# UNITED STATES PATENT AND TRADEMARK OFFICE

APPLICATION NO.	FILING DATE	FIRST NAMED INVENTOR	ATTORNEY DOCKET NO.	CONFIRMATION NO.
10/776,187	02/12/2004	Toshio Masuda	F0937-US	3078
21254	7590	11/30/2005		
MCGINN INTELLECTUAL PROPERTY LAW GROUP, PLLC 8321 OLD COURTHOUSE ROAD SUITE 200 VIENNA, VA 22182-3817			EXAMINER ADAMS, GREGORY W	
			ART UNIT	PAPER NUMBER
			3652

<b>Office Action Summary</b>	Application No.	Applicant(s)	
	10/776,187	MASUDA ET AL.	
	Examiner	Art Unit	
	Gregory W. Adams	3652

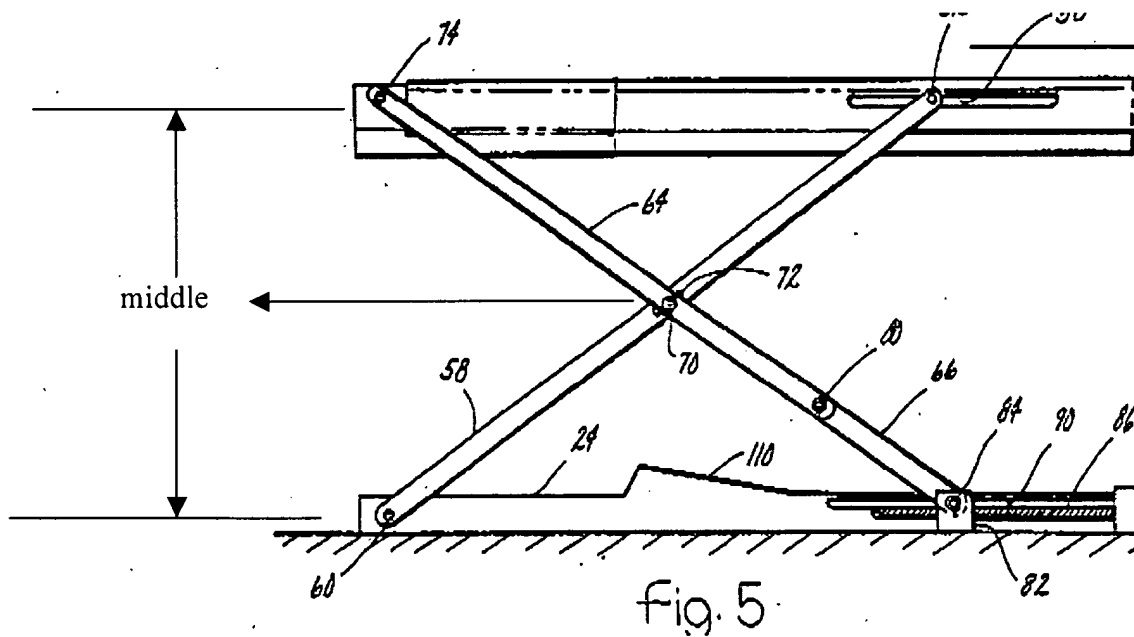
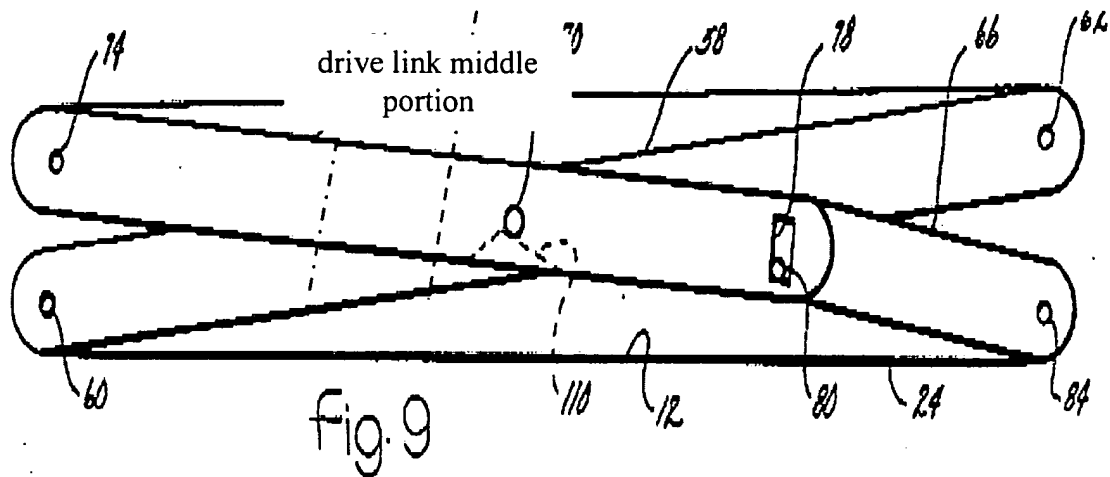
2. Claims 1-2 & 5 are rejected under 35 U.S.C. 102(b) as being anticipated by Pawl (US 4,969,793) (previously cited).

With respect to claim 1, Pawl discloses a concaved storage portion comprising a transfer mechanism, rail frame 24, drive links 64 connected between a rail frame 24 and a plate member 34 and driven links 58 connected between a rail frame 24 and a plate member 34 wherein drive links 64 connect with driven links 58 at a middle (see FIG. 5 below), a plurality of sliders 24 that engage with drive links 64, a driving mechanism 100 wherein each drive link includes a contacting portion 70 between a drive link middle portion and drive link first end (see FIG. 9 reproduced below) wherein a contacting portion 70 contacts a sloped slider 110 contacting surface. It is noted that Pawl's slider

permits sliding contact of a contacting portion 70 over a slider contacting surface 110 and sliding contact of pin 92 along slot 90. It is noted that a portion comprises a section, but not a point, i.e. a portion is a sub-length of an entire length. This proposition is supported by Applicant's contrasting use of portion and point. In Applicant's Specification, page 3, lines 4-5 a point is defined as a middle point for connecting two links contrasted with line 21 in which applicant defines a portion as that area of sloping sidewall in relation to a sloping sidewall. Thus, portion does not comprise a point.

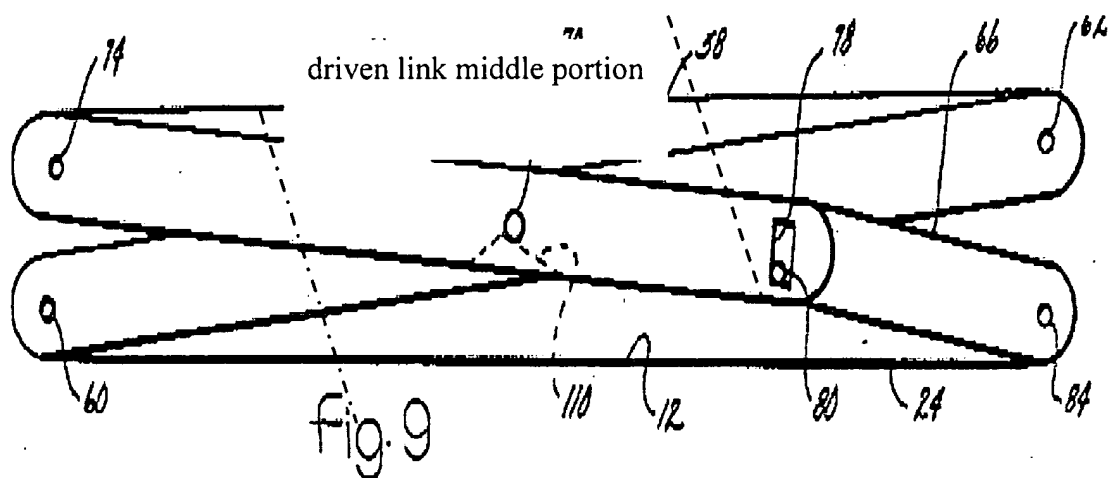
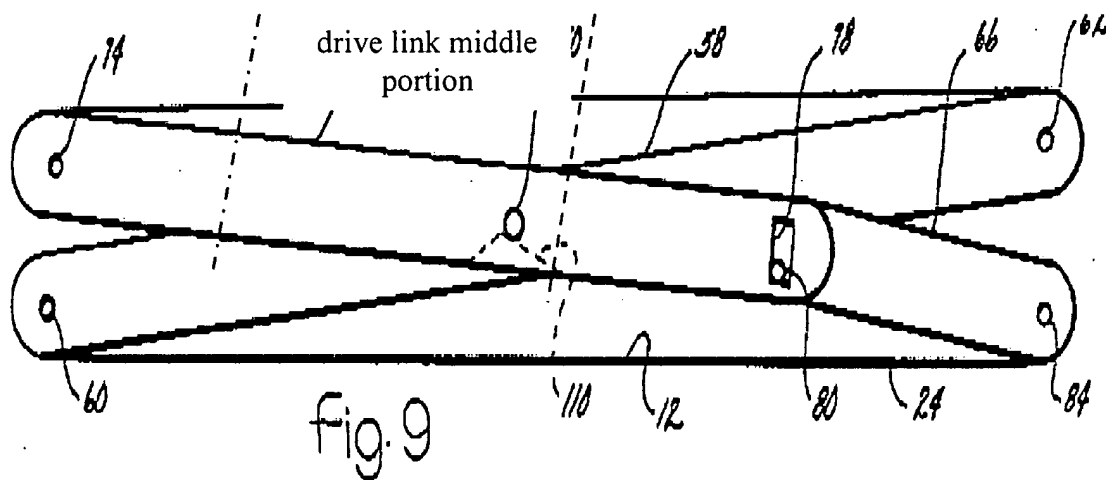
With respect to claim 5, Pawl discloses a plate member frame 36 connecting a drive link and driven link and a driving member 102. It is noted that broadly construed "driving member" is something that imparts motion or motive force to another object, e.g. shaft, motor, gear, pulley, cable or belt.

With respect to claim 7, Pawl discloses slider transfer guide groove 90, connecting link 66 connected to a drive link 64 and a slide pin 92 which transfer within a transfer guide groove 90.

With respect to claim 11, Pawl discloses an initial transfer zone where a contacting portion contacts a contacting surface and a normal transfer zone where driving force is transmitted from a slider.

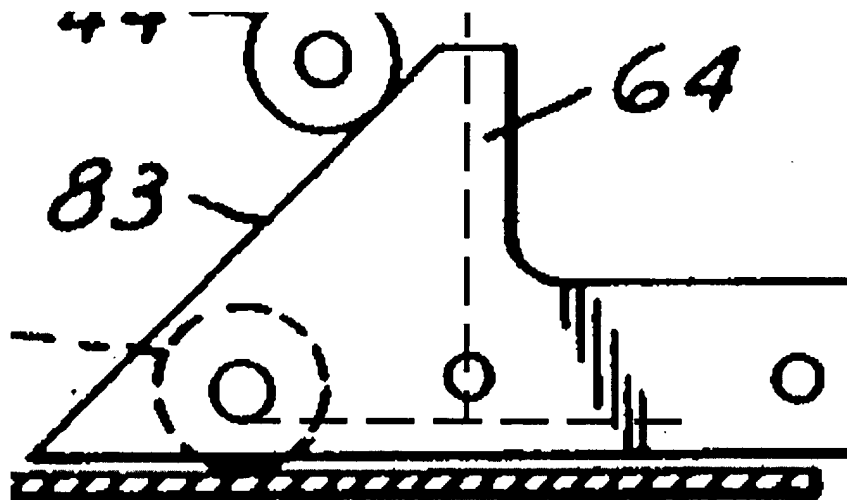
With respect to claim 13, Pawl discloses a middle portion of each driven link is connected with a middle portion of each drive link. For example, as shown in FIG. 9 reproduced below a middle portion for a drive link is approximated as well as a driven link middle portion.
